INITIAL FIRE SAFETY INSPECTION REPORT

AMC Knit Composite Ltd. (Extension - 2)

RSC ID: 25894

Date: 04-May-2025

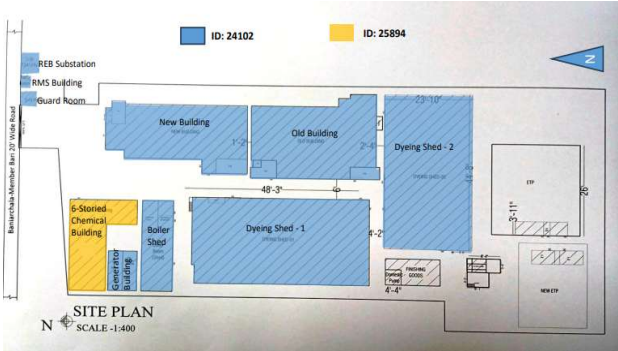
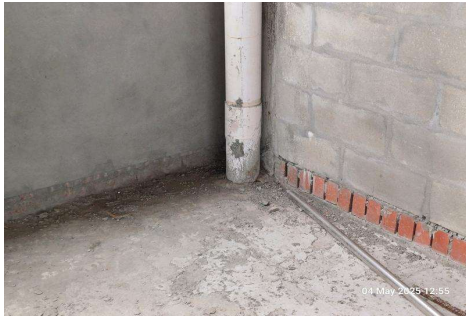
The six storied building is provided with only one exit stair. Single exit serving the ground floor to 5th floor, whereas single exit is permitted only for ground floor for Occupancy-J (with maximum occupant 5 and maximum travel distance 8m, ref: table-4.3.4 of BNBC 2020).

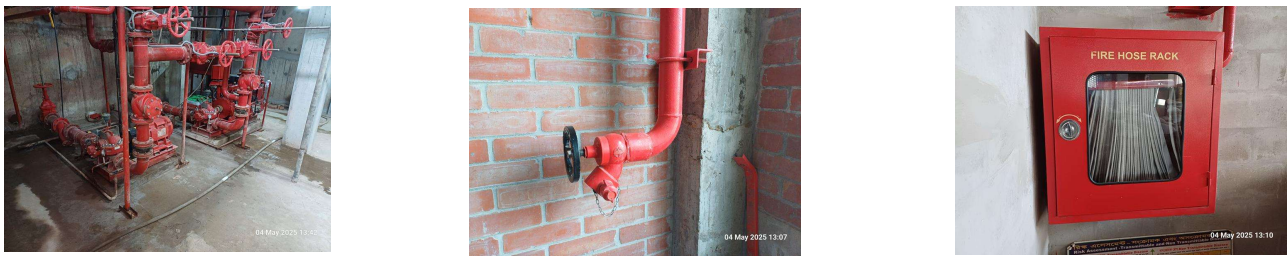
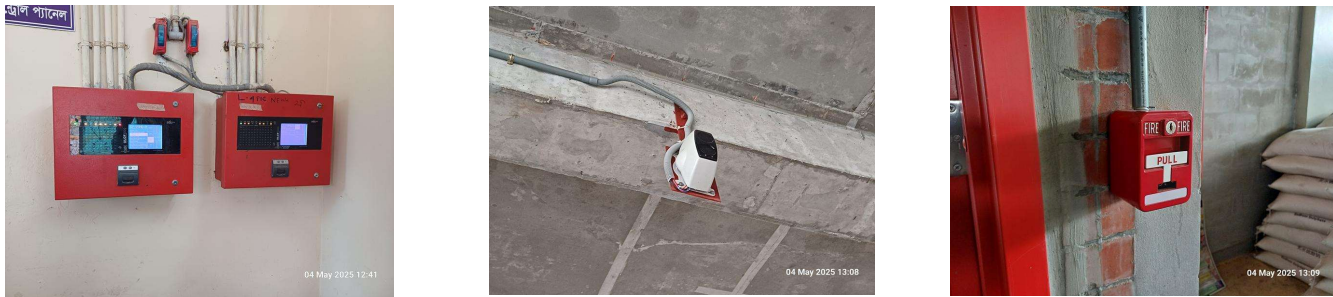
F-04	Fire Rated Construction	Elevator shafts open directly into the work area without proper fire separation due to unprotected opening. Location: 4th & 5th Floor	Elevator shaft shall be separated from production area by 2 hours fire rated construction. 2-hr fire barriers shall be protected with minimum 1.5-hr fire protective opening assemblies.	Within 3 Months
